NMOCD approves of the proposed
delineation for 1RP-4977.

**1RP-4977
DELINEATION PLAN
Natural Gas Release
8" North of Monument Plant
Lea County, New Mexico**

LAI Project No. 18-0124-01

March 22, 2018

Figure 3 - Aerial Map and Proposed Soil Sample Locations

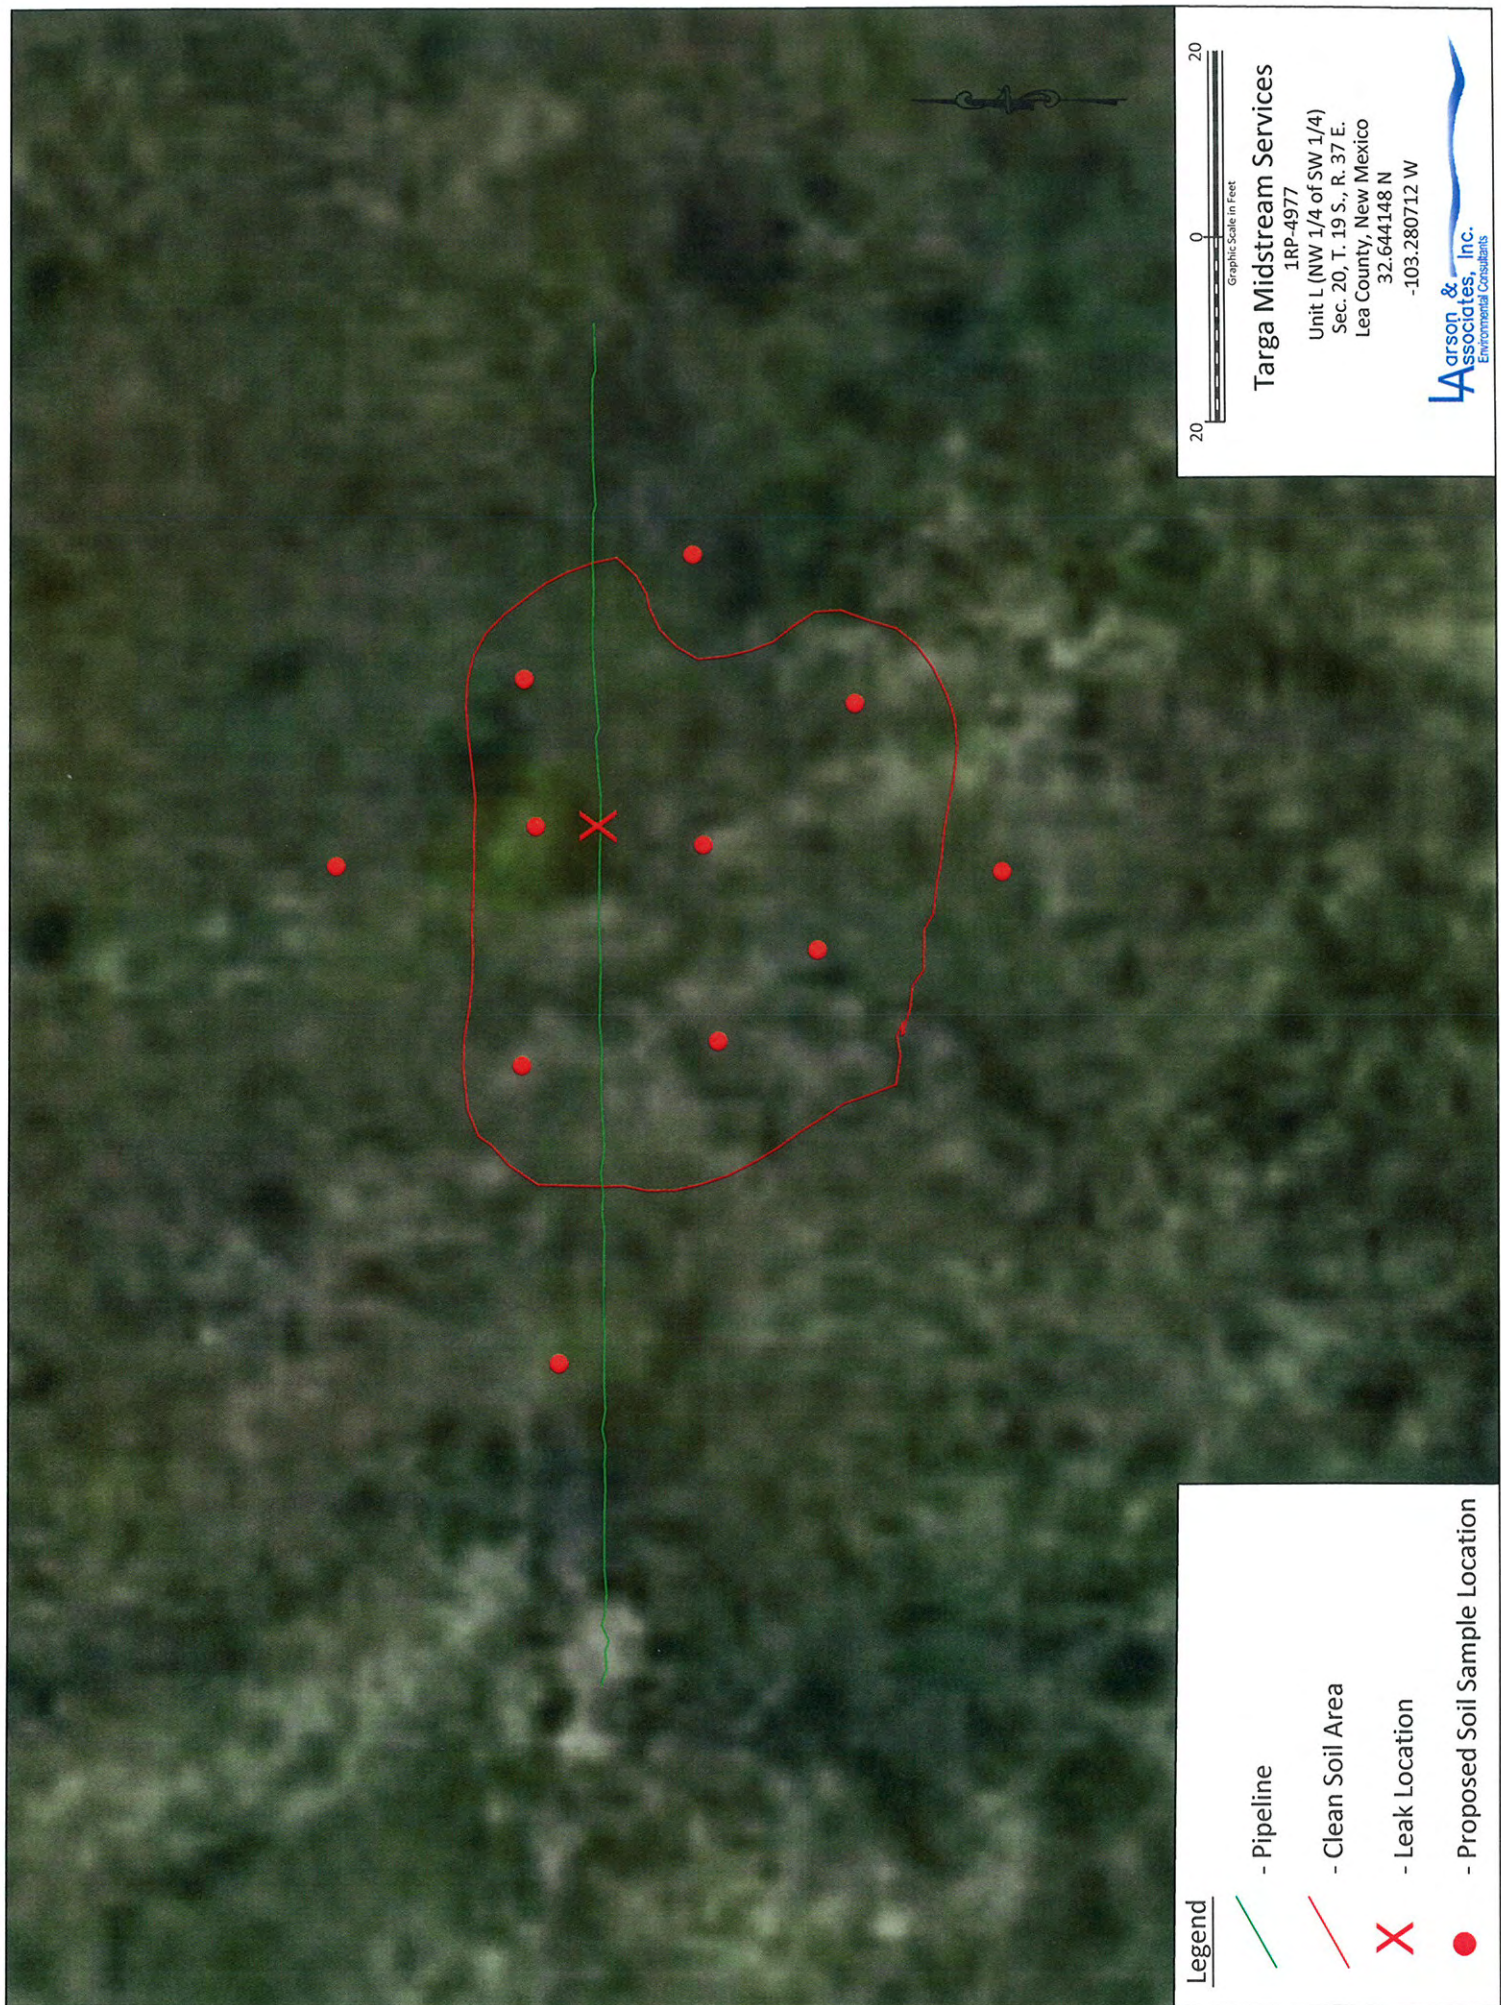
Delineation and remediation levels
for chlorides are 600 mg/kg.
